Access Compliance Report

Public Rights-of-Way

Intersection ID: 15402	Main Street: MARSH_RD	Cross Street: NEW_BERN_ST	Location: SE
ADA ID: 96410BA67AD7	Ramp Type: Perp	Initial Pass/Fail: Fail	Overall Compliance: No
Codes/Mitigation Info/Possible Solution		Field Measurements/Component Compliance

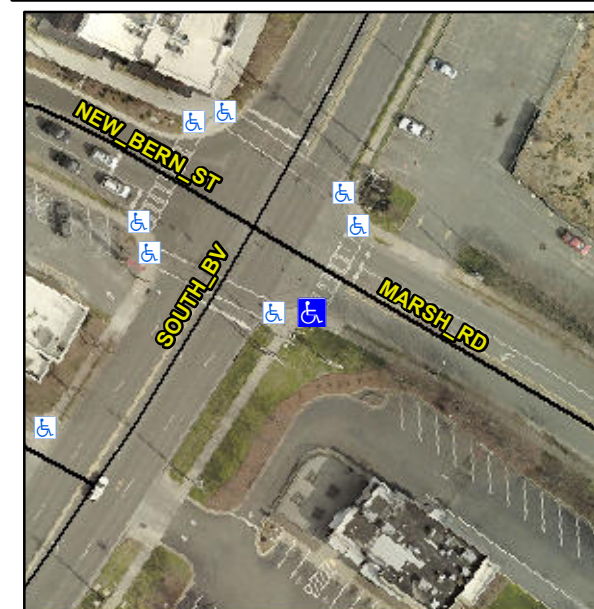
Not Found, R304.2.2, R304.5.3

Compliance	Description	Data	Compliance	Description	Data
N/A	Ramp Length (in)	25.5	No	Ramp Slope (%)	8.9
Yes	Ramp Width (in)	48.0	No	Ramp XSlope (%)	3.0
N/A	Flare Type LT	N/A	N/A	Flare Type RT	N/A
N/A	Flare Slope LT (%)	N/A	N/A	Flare Slope RT (%)	N/A
N/A	Flare Traversable LT?	N/A	N/A	Flare Traversable RT?	N/A
N/A	Landing Length (in)	N/A	N/A	DWS Provided?	N/A
N/A	Landing Width (in)	N/A	N/A	DWS Contrast?	N/A
N/A	Landing Slope (%)	N/A	N/A	DWS Length (in)	N/A
N/A	Landing X Slope (%)	N/A	N/A	DWS Full Width?	N/A
N/A	Landing Curb? (Y/N)	N/A	N/A	DWS Offset (in)	N/A
N/A	Shared Landing?	N/A			
N/A	Gutter Ponding?	N/A	N/A	Gutter Slope (%)	N/A
N/A	Gutter Lip Ht (in)	N/A	N/A	Gutter X Slope (%)	N/A
N/A	Painted X Walk1?	Yes	N/A	Painted X Walk2?	N/A
	X Walk 1 Direction	To NE		X Walk 2 Direction	N/A
N/A	X Walk 1 Width (in)	112.0	N/A	X Walk 2 Width (in)	N/A
	X Walk 1 Slope (%)	1.2		X Walk 2 Slope (%)	N/A
	X Walk 1 X Slope (%)	1.9		X Walk 2 X Slope (%)	N/A

Remove & Replace Entire Ramp.
